A New Residence For Jeff, Beth & Matt Fischer

Lot 5 - Hermitage - High Springs, Florida

Review for Code Compliance
Universal Engineering Science

Floor Plan

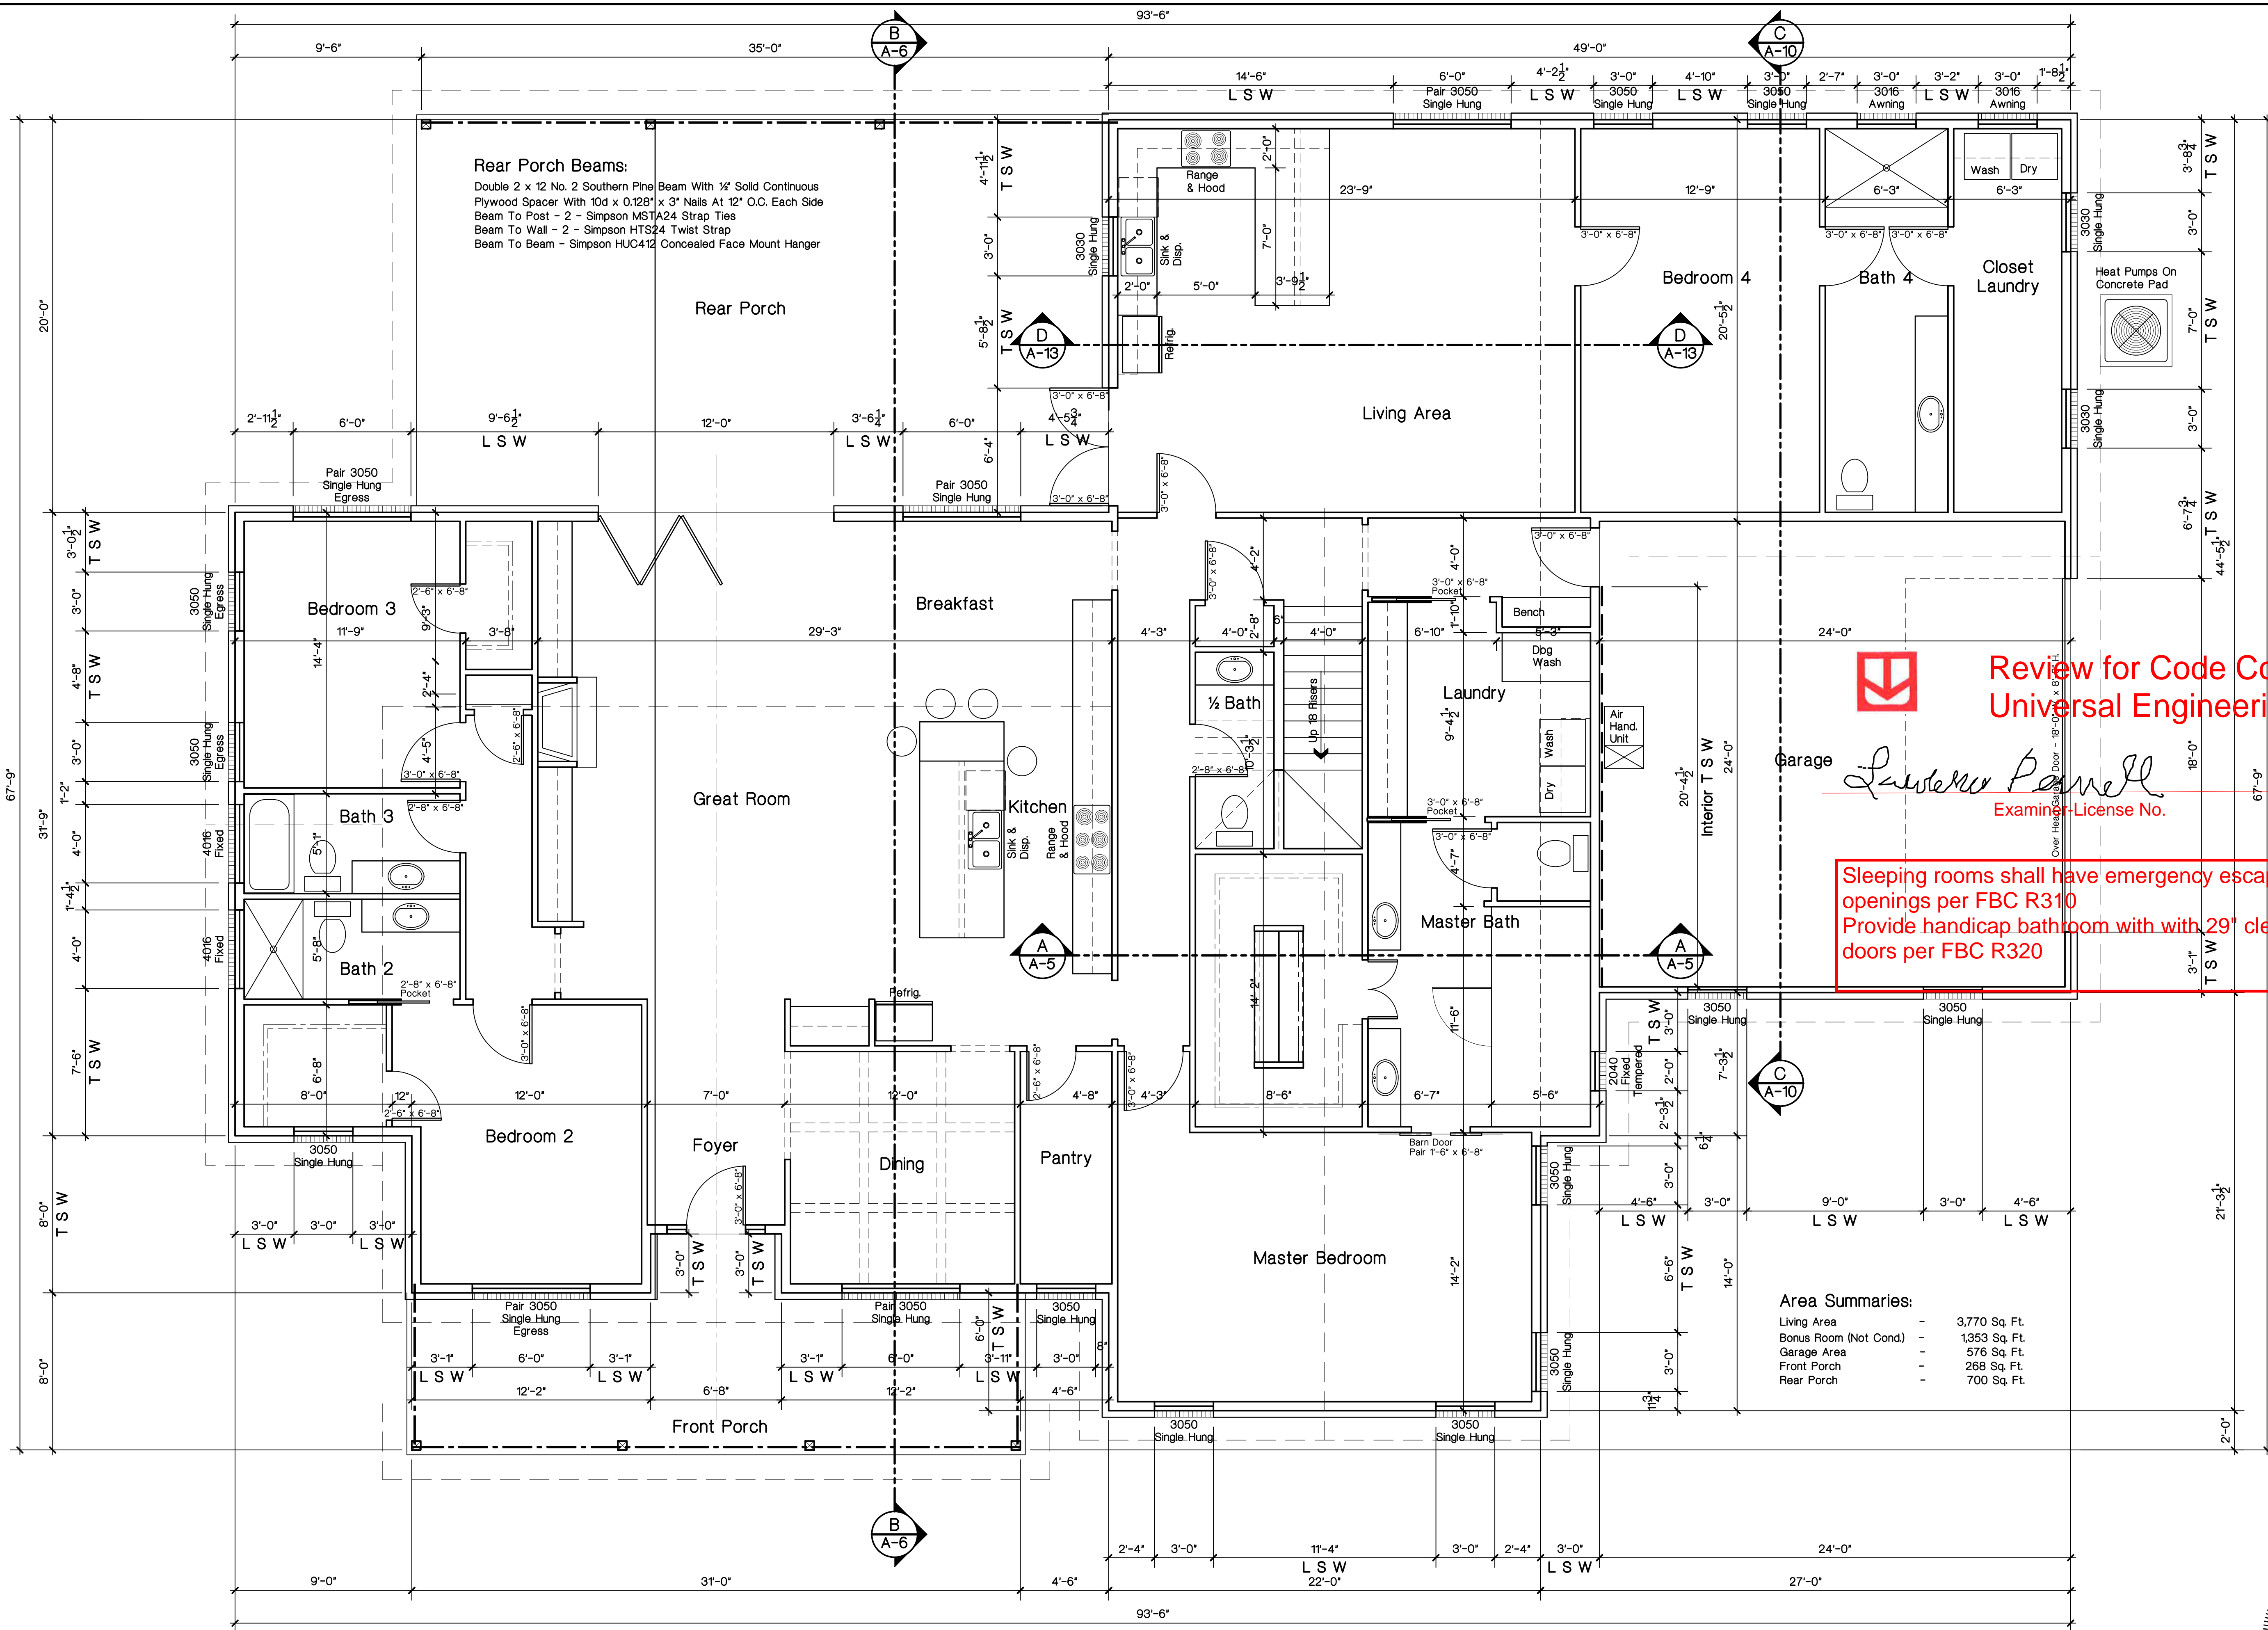
Review for Code Compliance
Universal Engineering Science
Lawrence Parnell
Examining License No. PX2707
11/26/2023
Sleeping rooms shall have emergency escape rescue openings per FBC R310
Provide handicap bathroom with with 29" clear opening doors per FBC R320

Stair Profile Detail

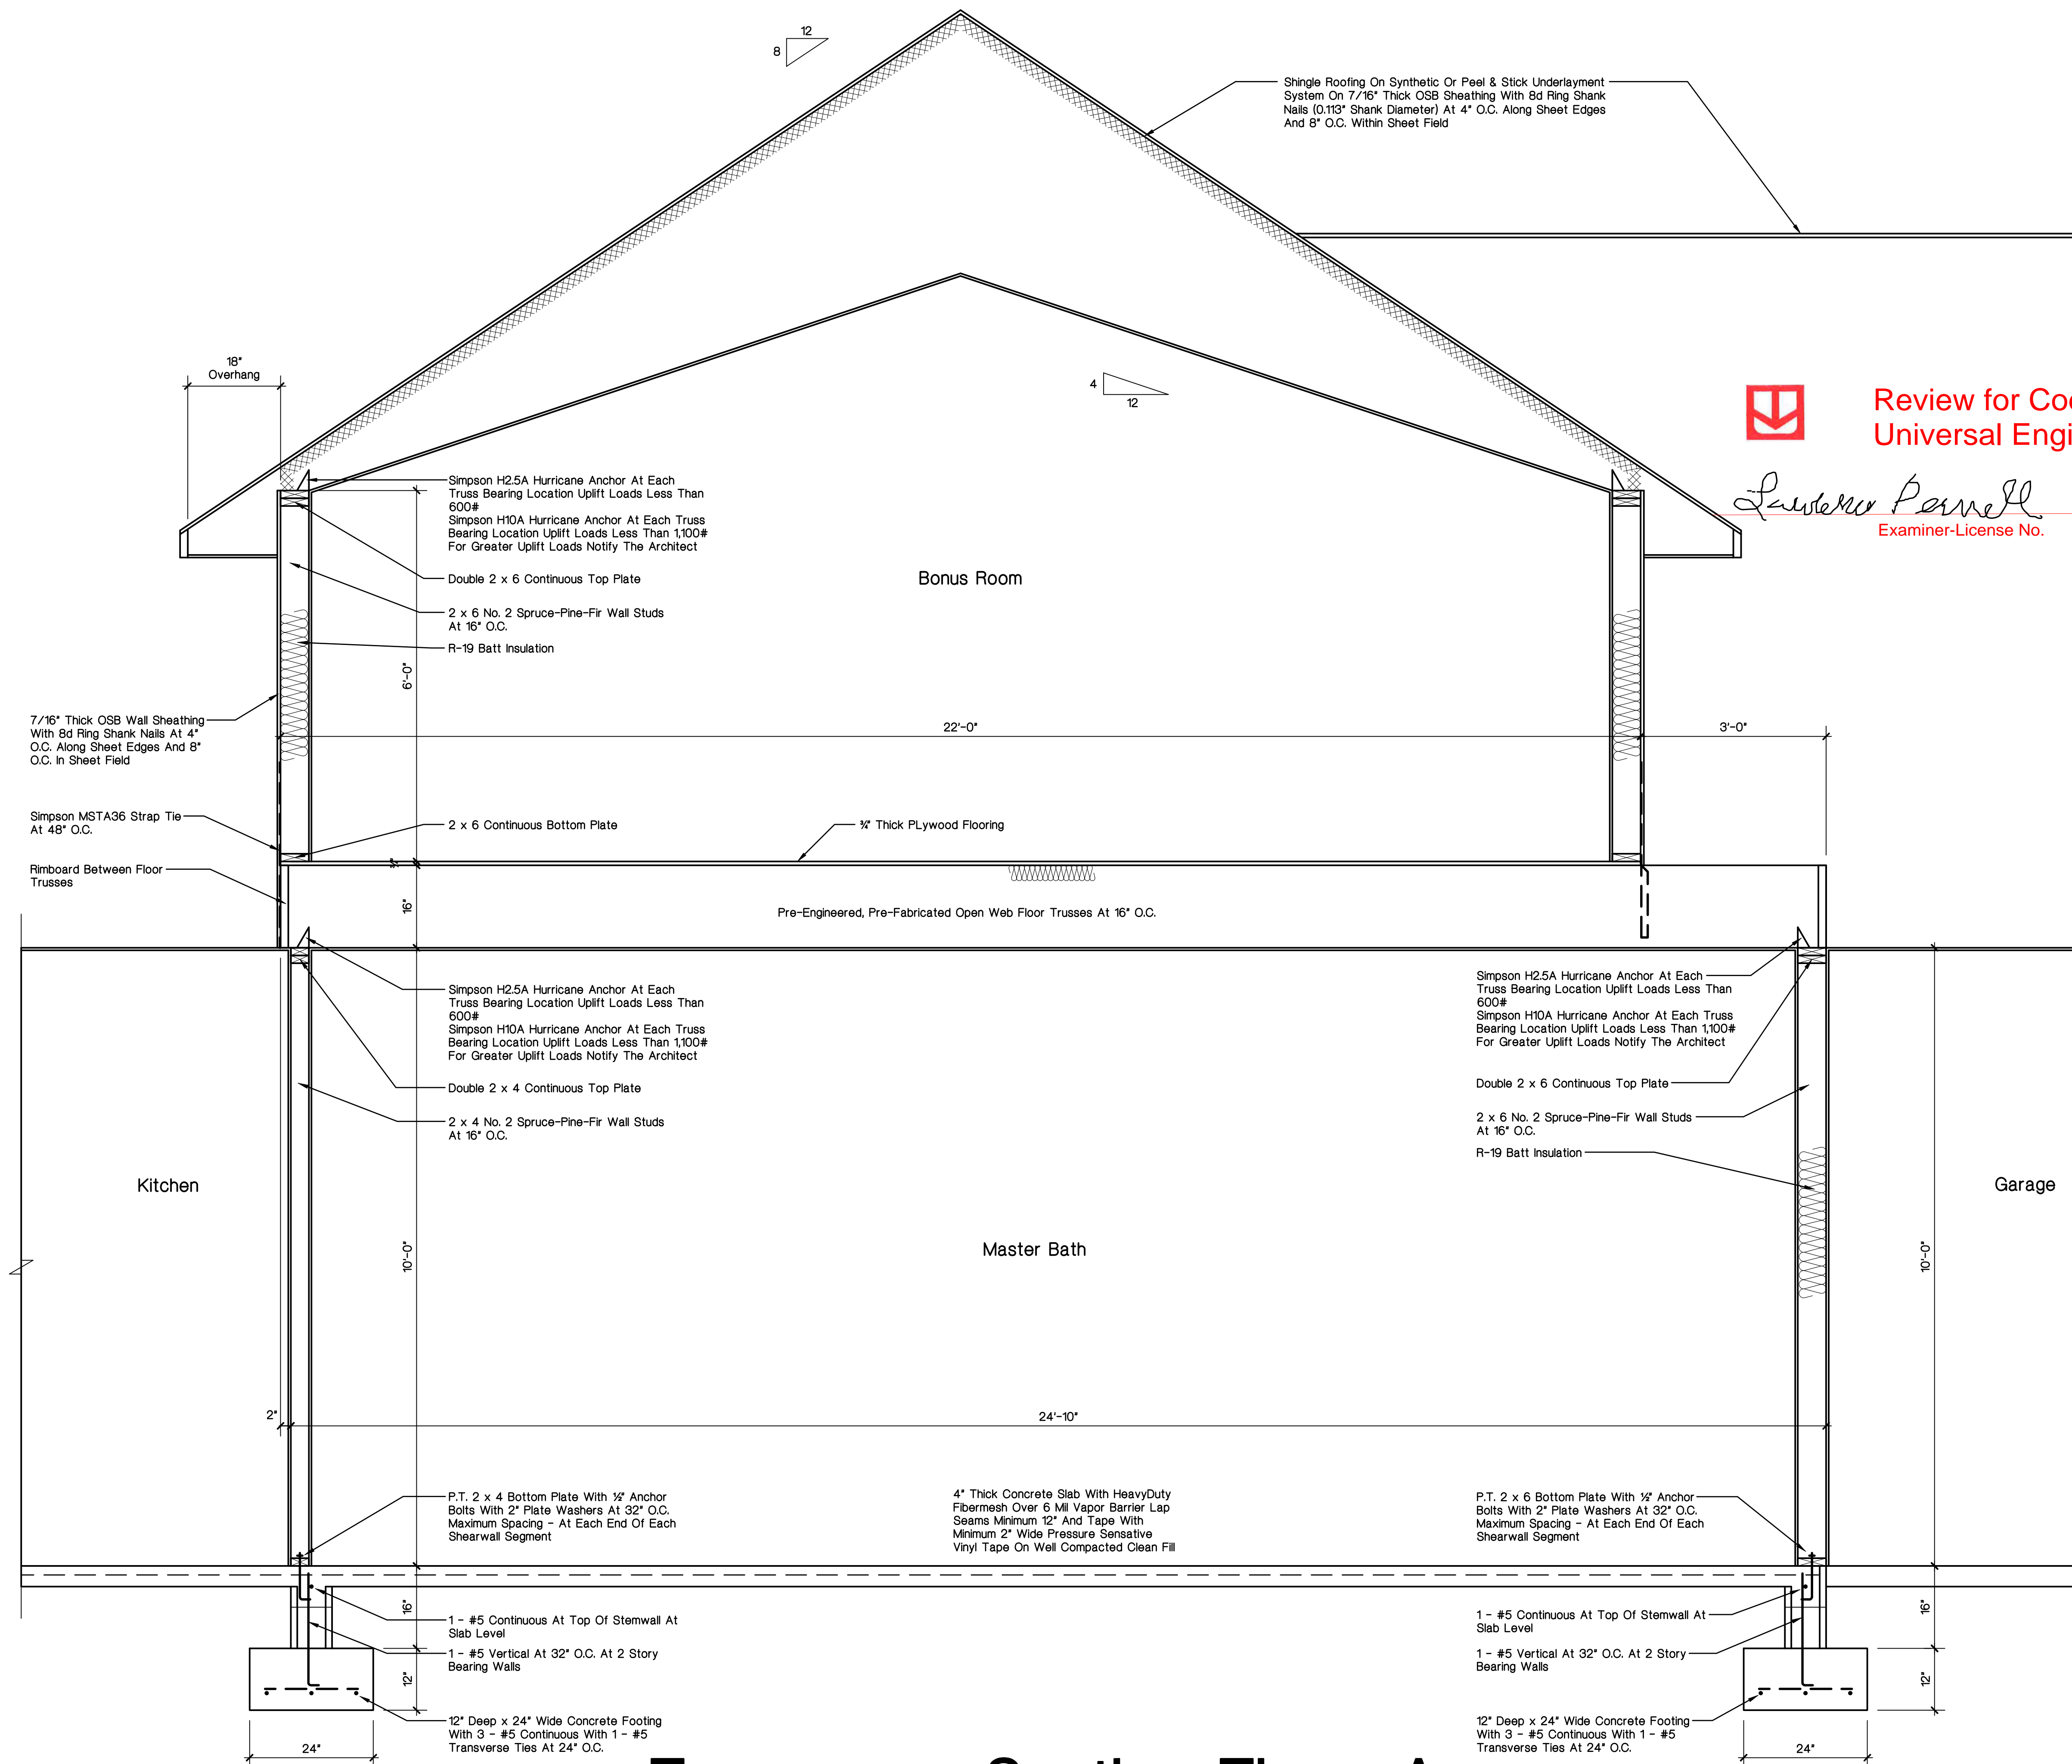
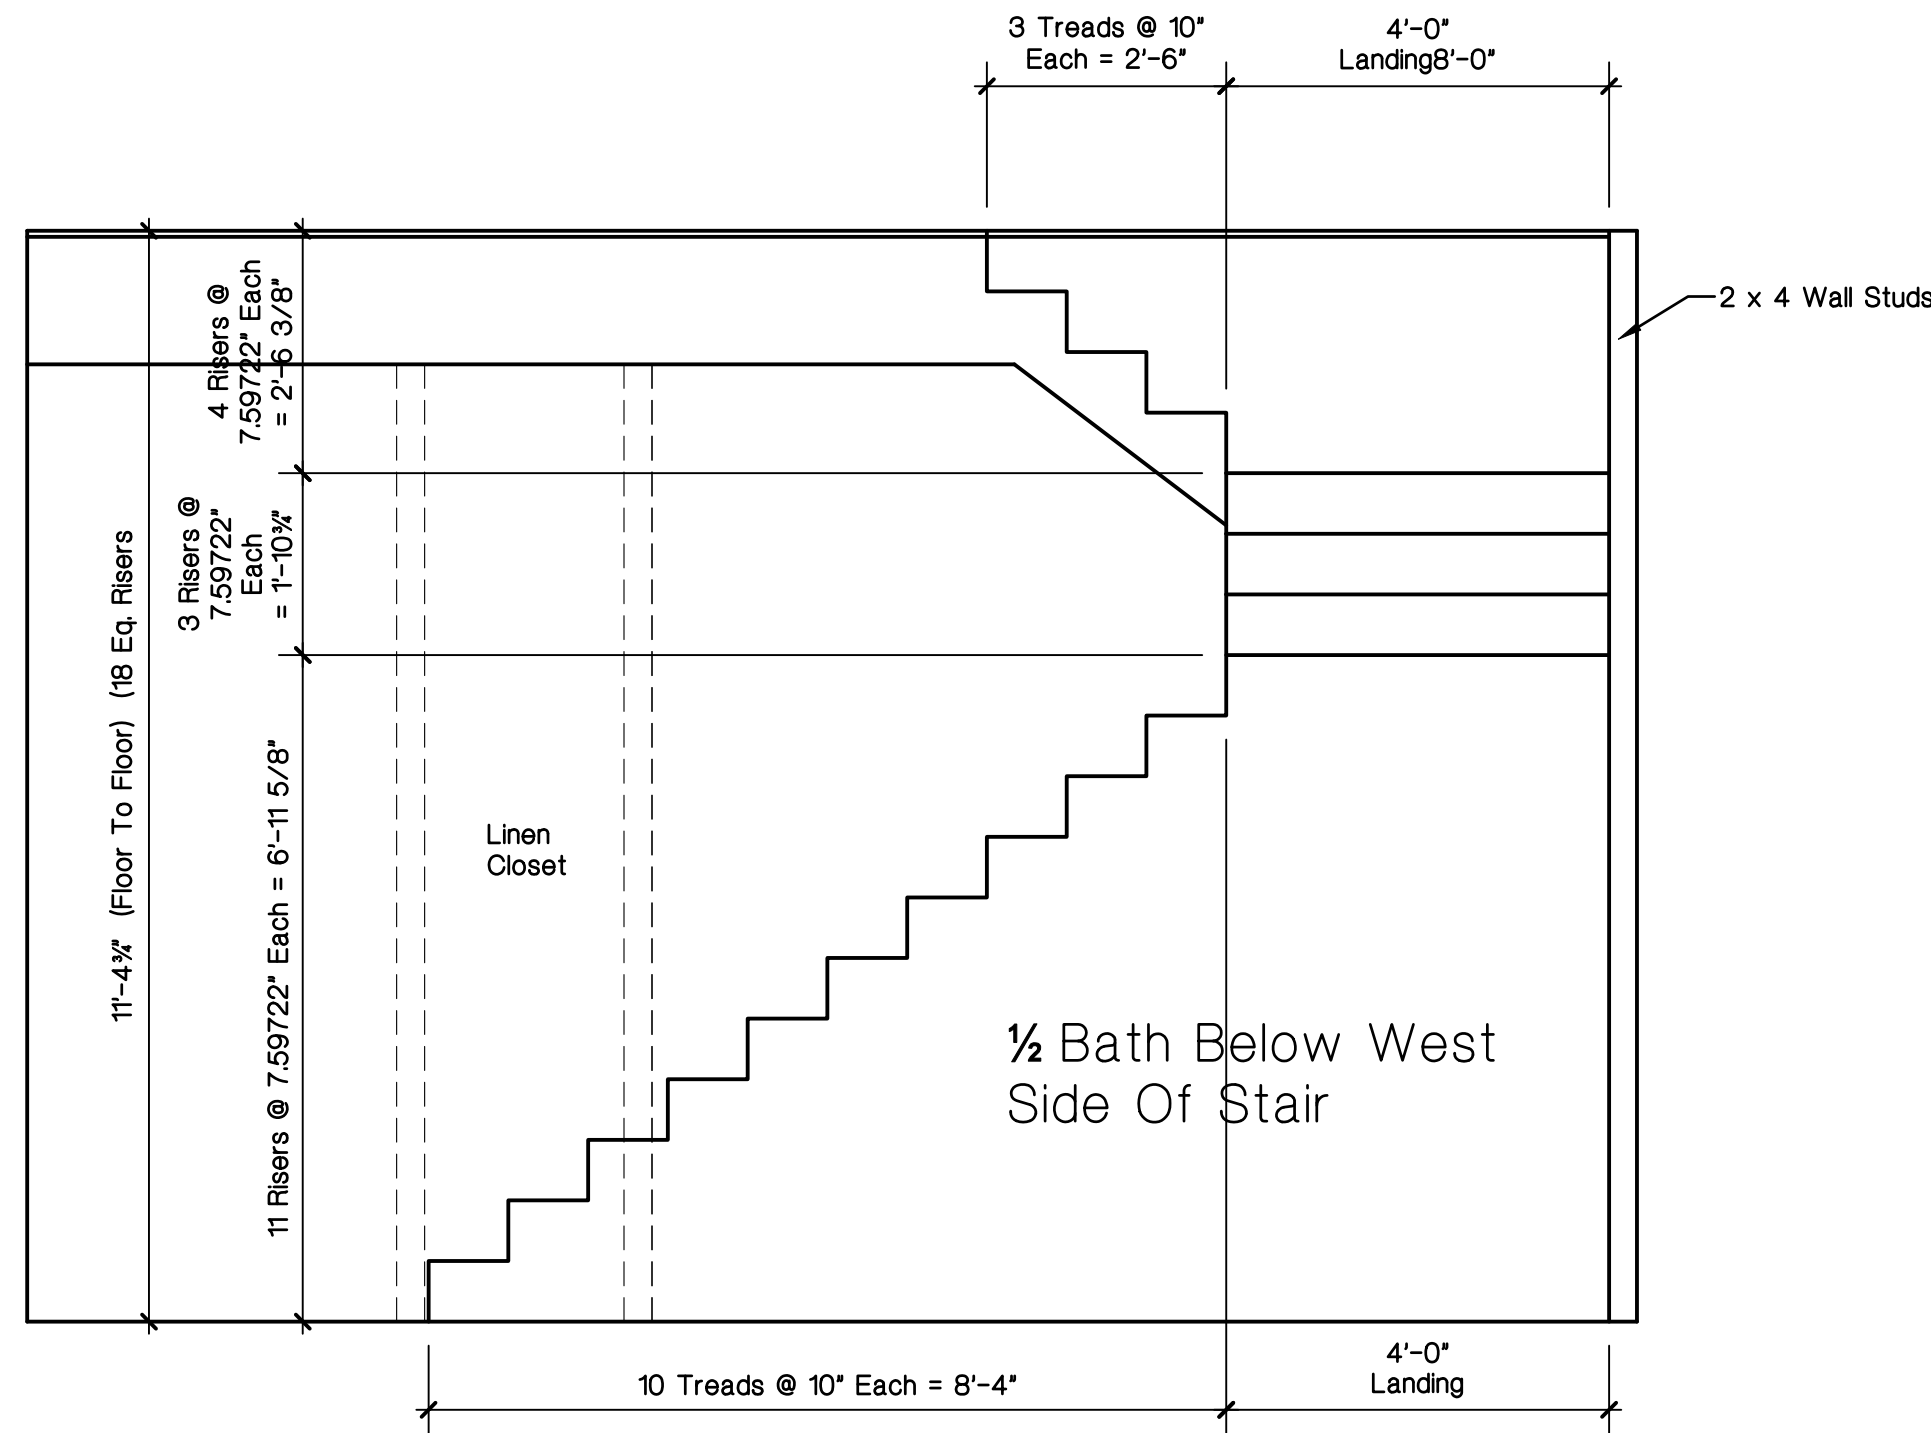
Stairs winder treads per
R311.7.5.2
